Ventura County Community College District

DATE: June 12th, 2023
TO: All Bidders
FROM: David Cienfuegos, Purchasing Specialist
SUBJECT: Addendum 2 – Bid 650, Moorpark College Sand Volleyball Project

DEMOLITION PLAN

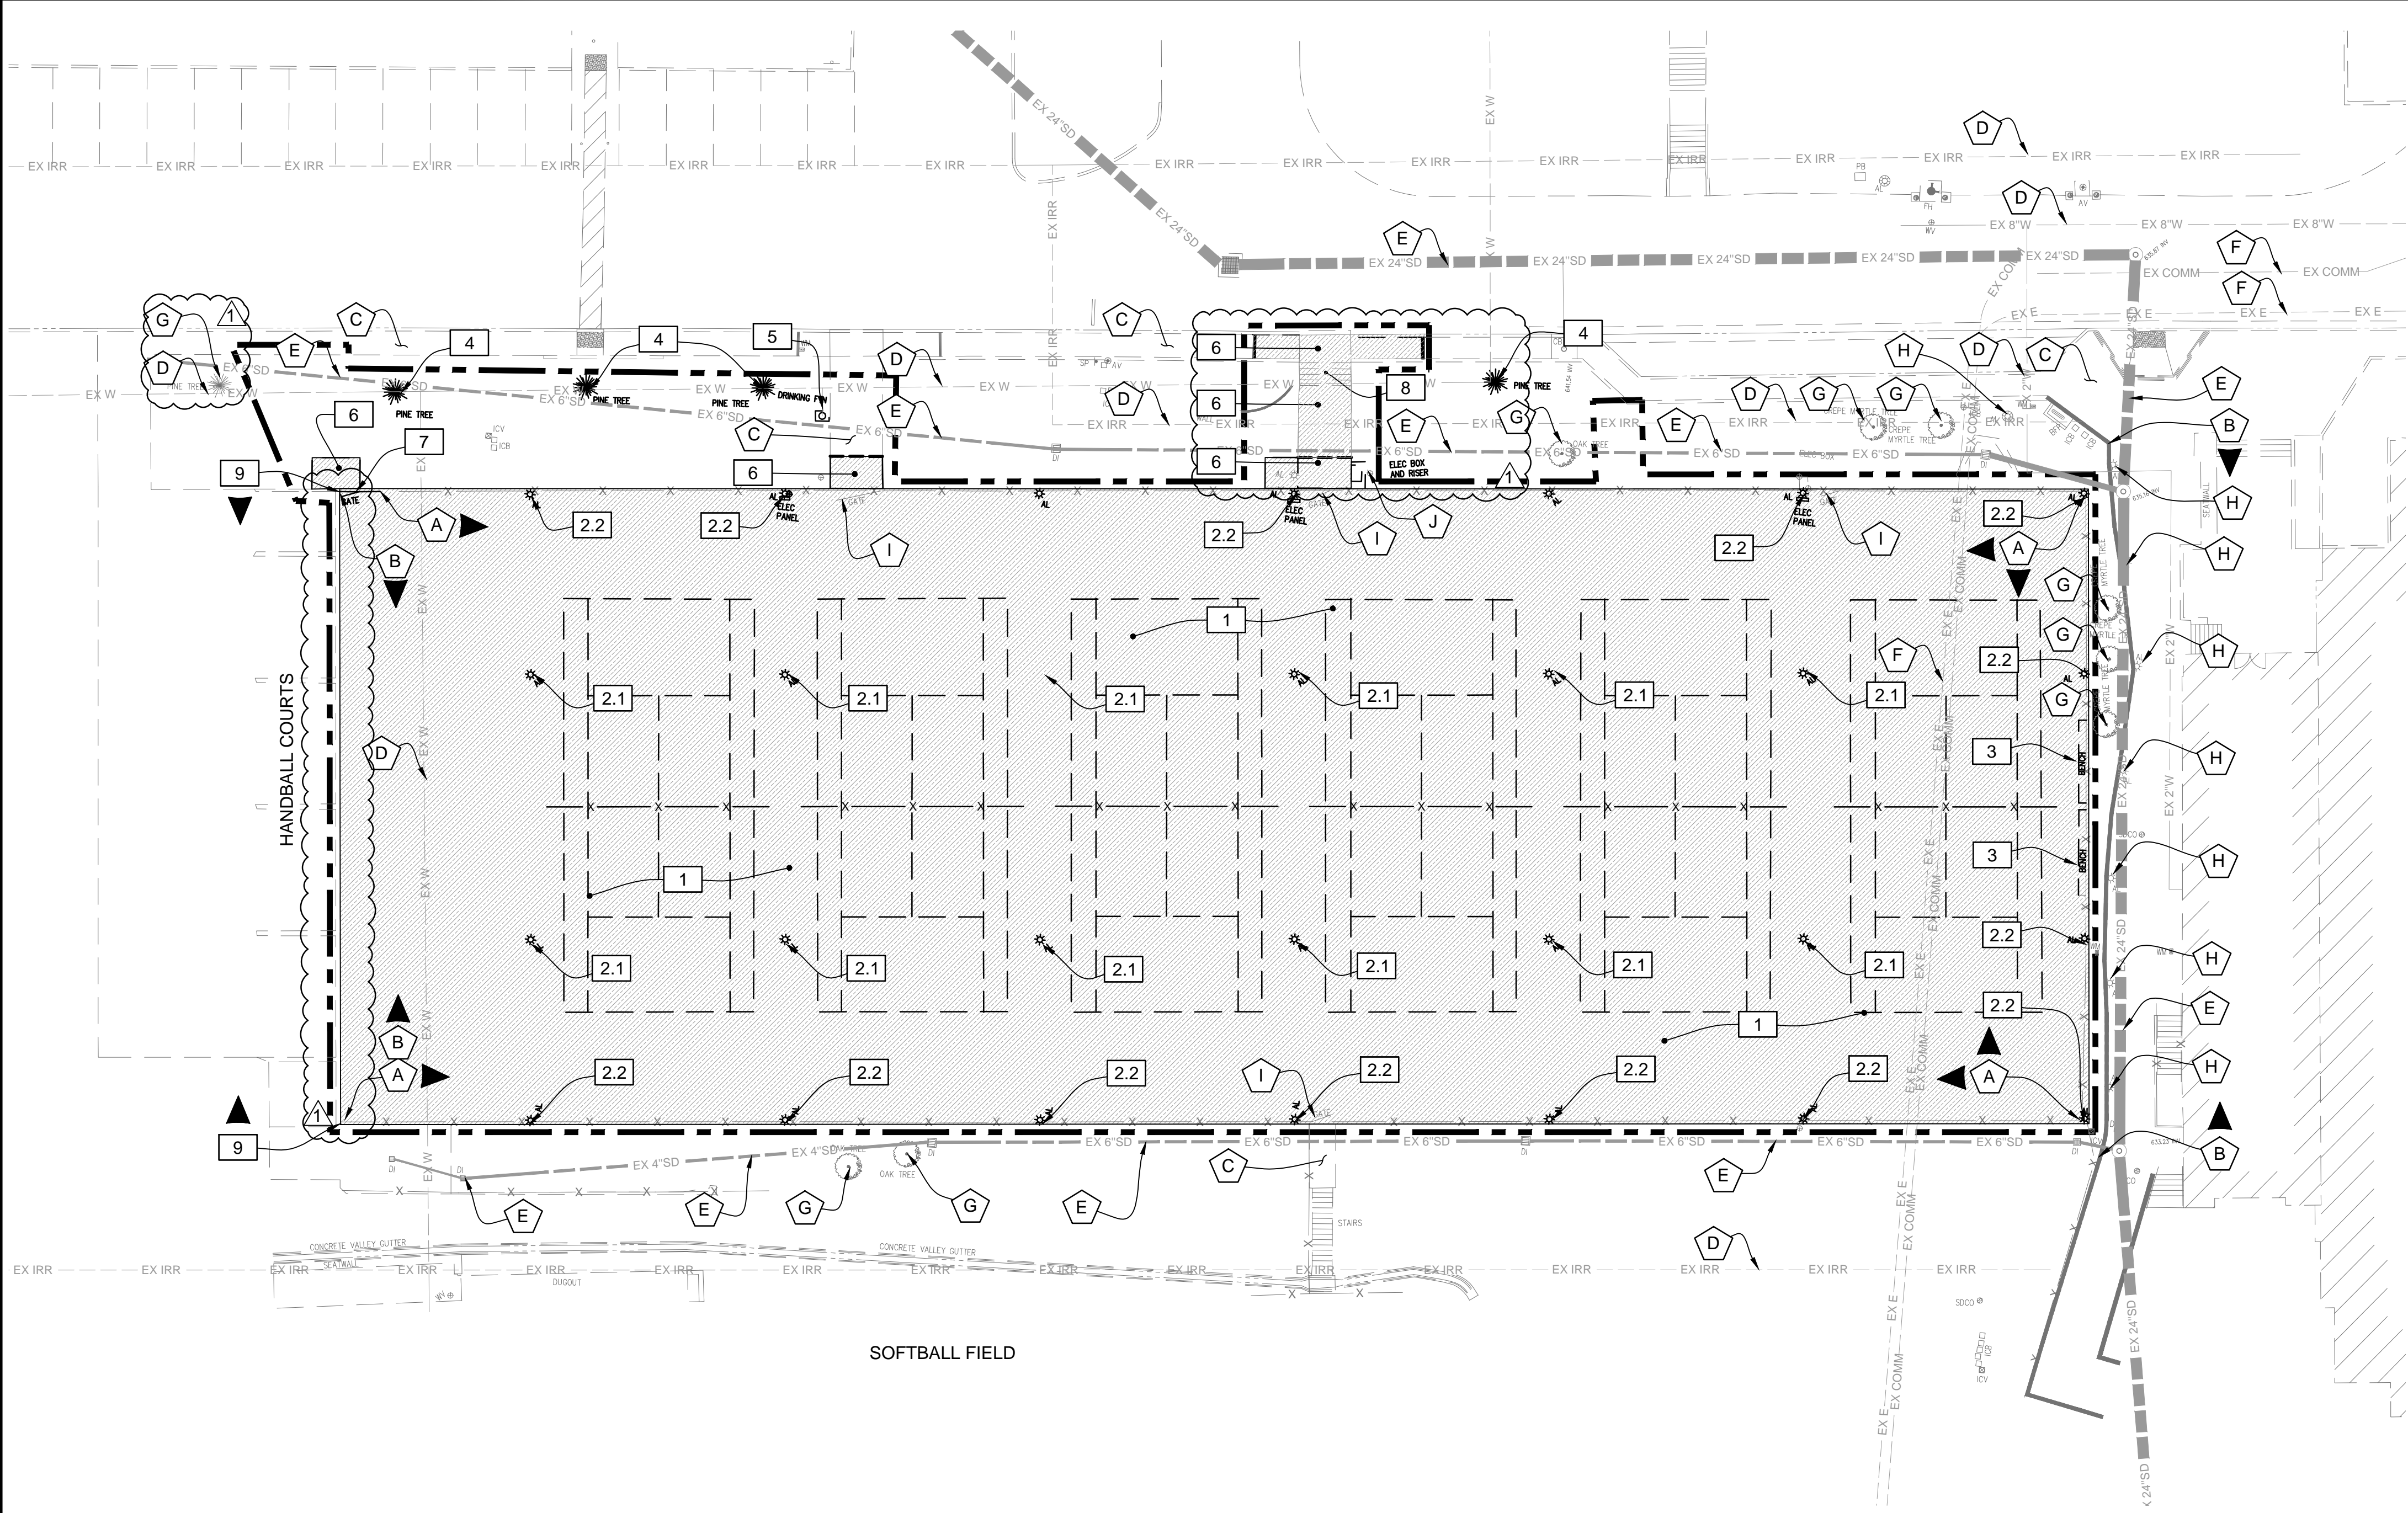
1. Please confirm the quantity and location of the existing pine trees that should be removed as part of this contract.

3. Please confirm that the light poles demo, as shown on 2/C2-02, will include the removal of the concrete base in its entirety (not only below the subgrade).

21. Sheet C2-02 shows 3 trees to be removed, but during the job walk there was discussion of a 4th tree to be removed. Can you please confirm?

22. Sheet C2-02 Demo Note #1 refers to the existing courts as concrete, but during the job walk discussions they were referred to as and appeared to be asphalt? Can you please confirm?

Response: Refer to revised sheet C2-02 Demolition Plan.

Response: Refer to revised sheet C2-02 Demolition Plan for light poles to be entirely removed (including concrete base) and poles that will be partially removed.

Response: Refer to revised sheet C2-02 Demolition Plan.

Response: The existing court section consist of asphalt over concrete pavement

Response: Total thickness of existing court pavement is approximately 8", 4" of asphalt over 4" of concrete base.

SURFACING PLAN

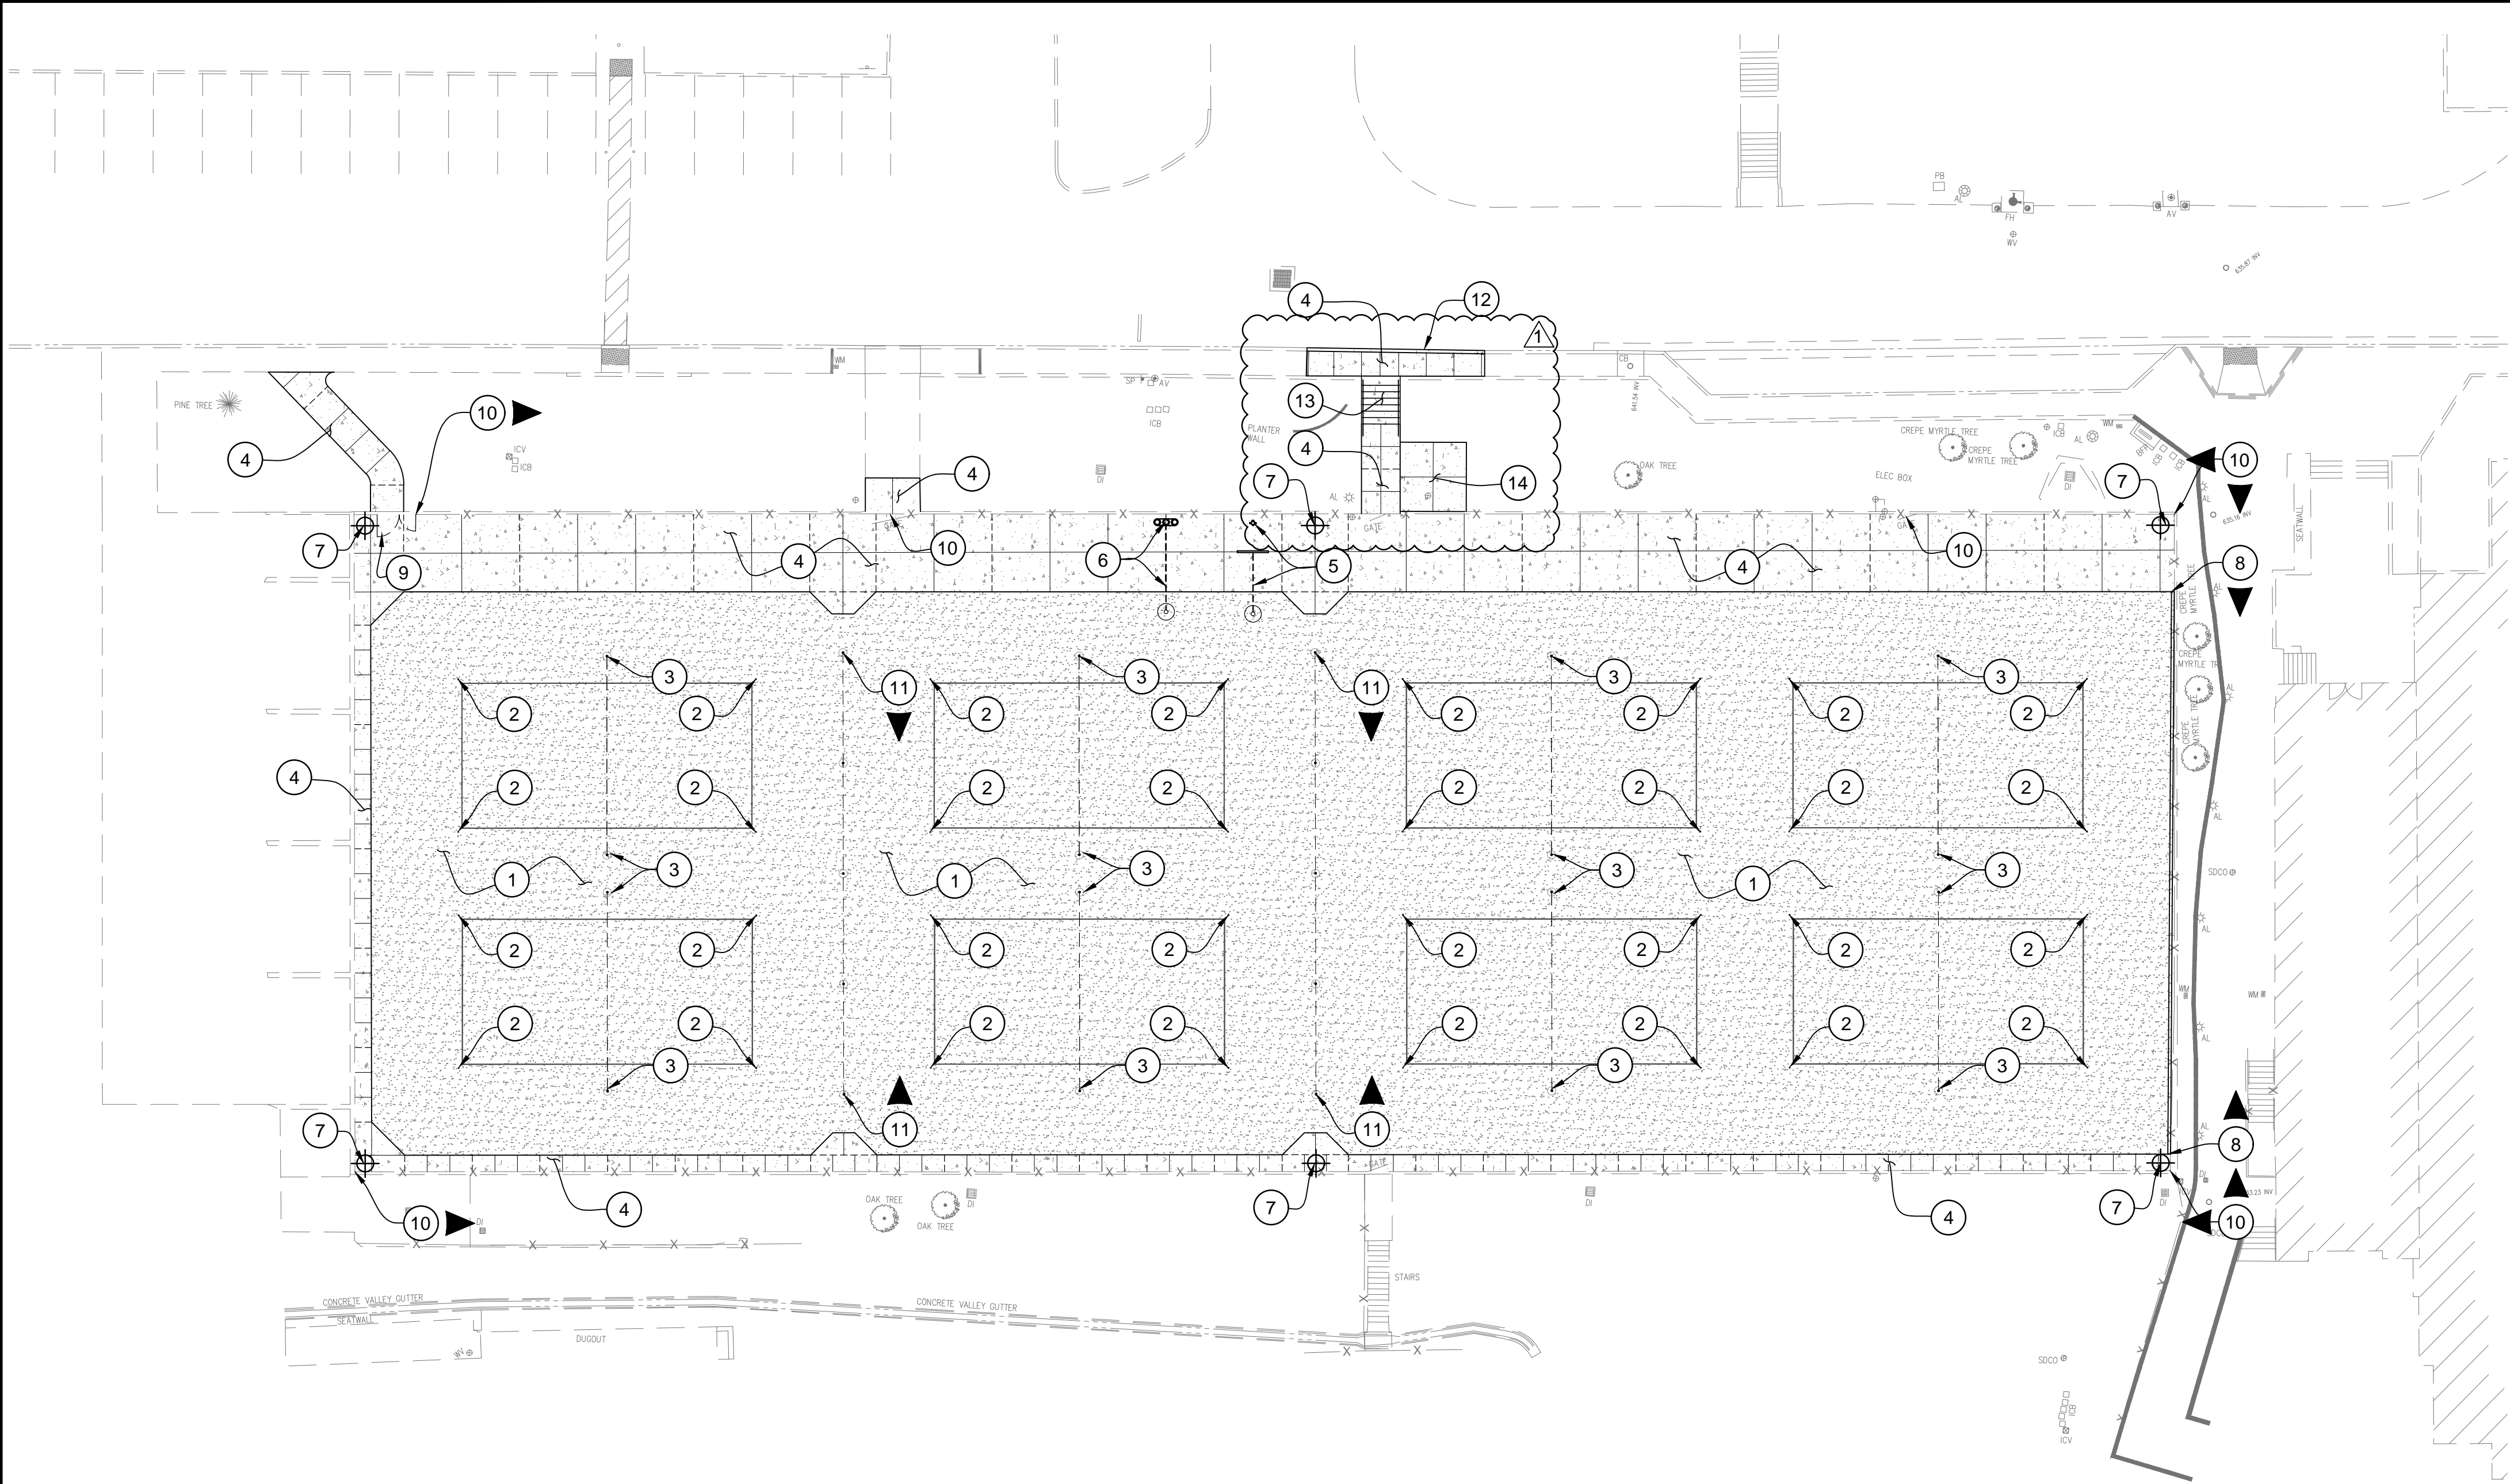
2. Please confirm that the scope of work for the north side stairs and handrails, as shown on C1-00, will change following the discussions of the pre-bid meeting.

4. Please clarify the CL fence scope of work. Should we remove and replace both the chain link fence and windscreen at all the perimeter fence (No modifications to the existing posts)?

Response: Refer to revised sheet C3-01 Surfacing Plan. Scope for north side stairs and handrails include: removal of existing concrete stairs, concrete pavement, and curb to limits shown. New concrete curb, sidewalk, stairs and handrails. New stairs to be 7' in width maximum between rails.

Response: Refer to revised sheet C3-01 Surfacing Plan for clarified chain link fence scope.

1 VOLLEYBALL COURT SAND PROFILE
NTS

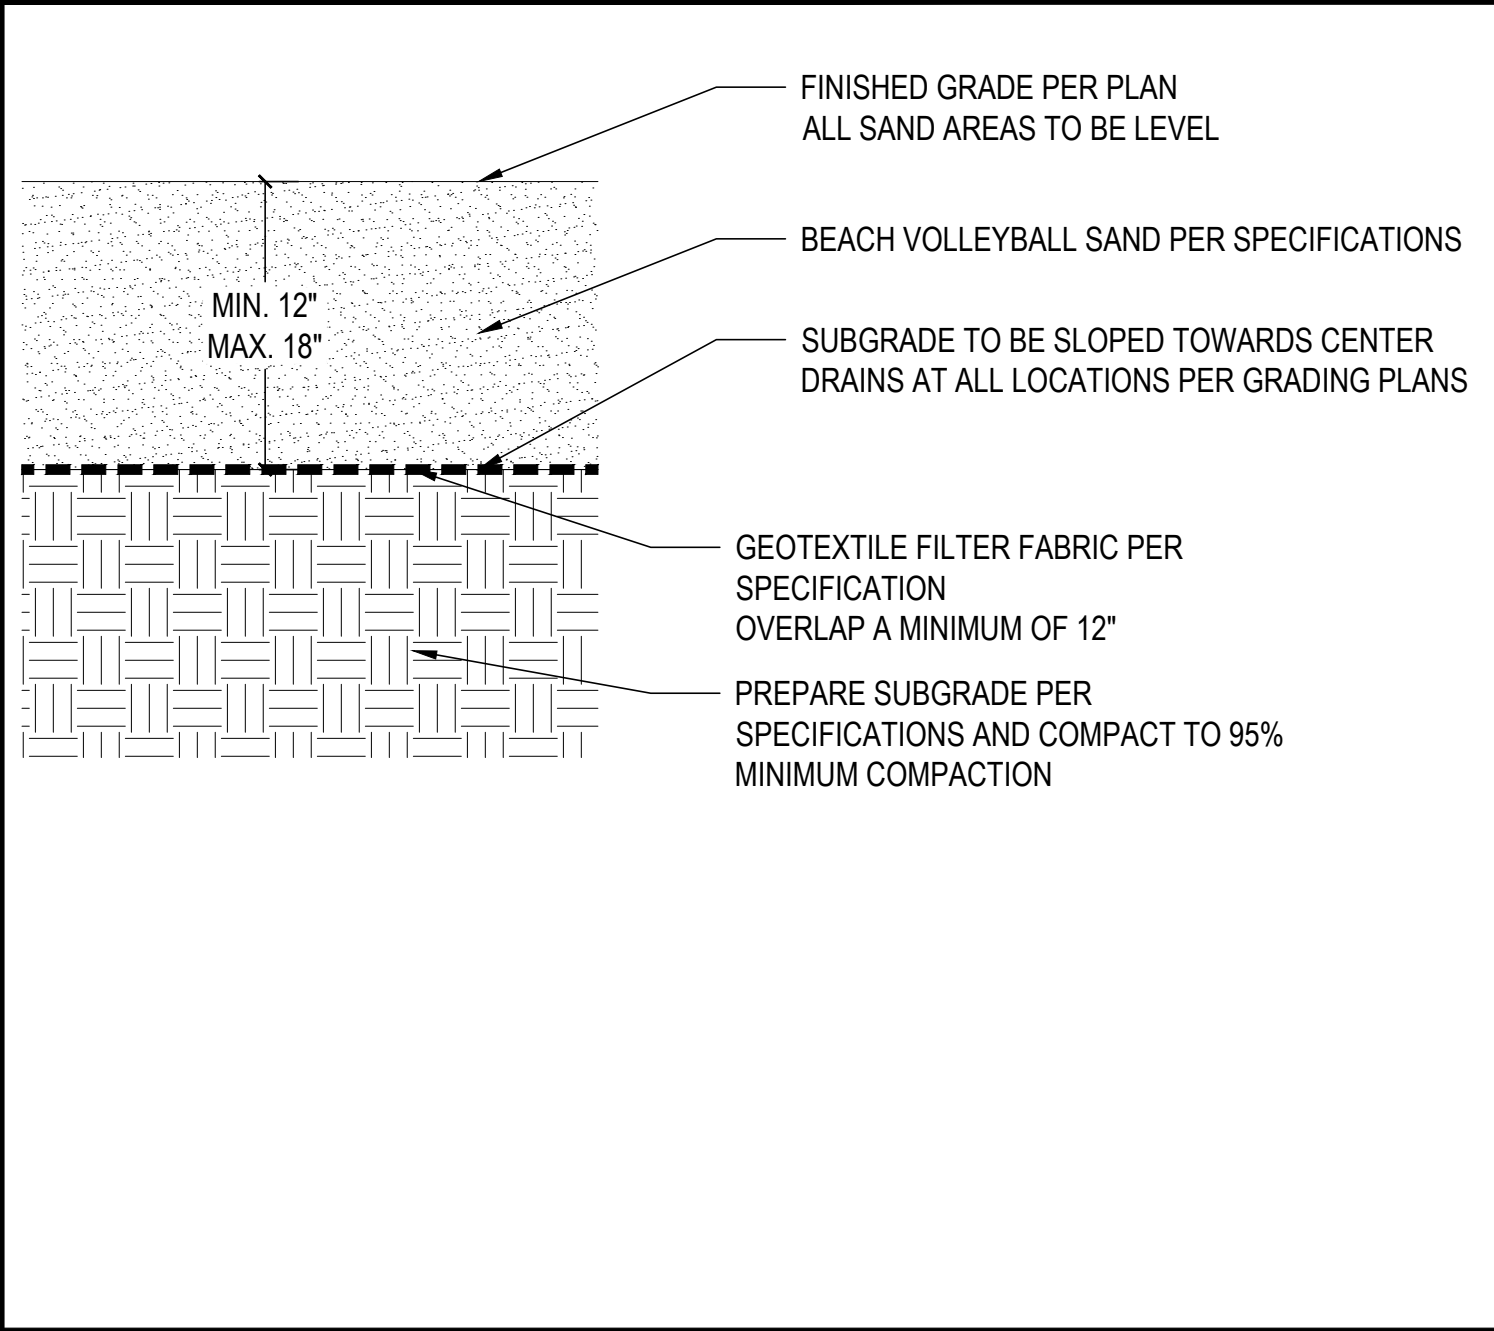
20. The plans call for min 12" and max 18" sand (detail 1 sheet C3-02). So contractors can bid equally, what uniform sand depth should we bid for?

Response: Refer to plans and calculate sand volume accordingly. Per the plan sheets and Sections 1 and 2 on sheet C5-03 Grading Sections, sand depth at areas outside of playing area is 12". Depth of sand in playing area is 18".
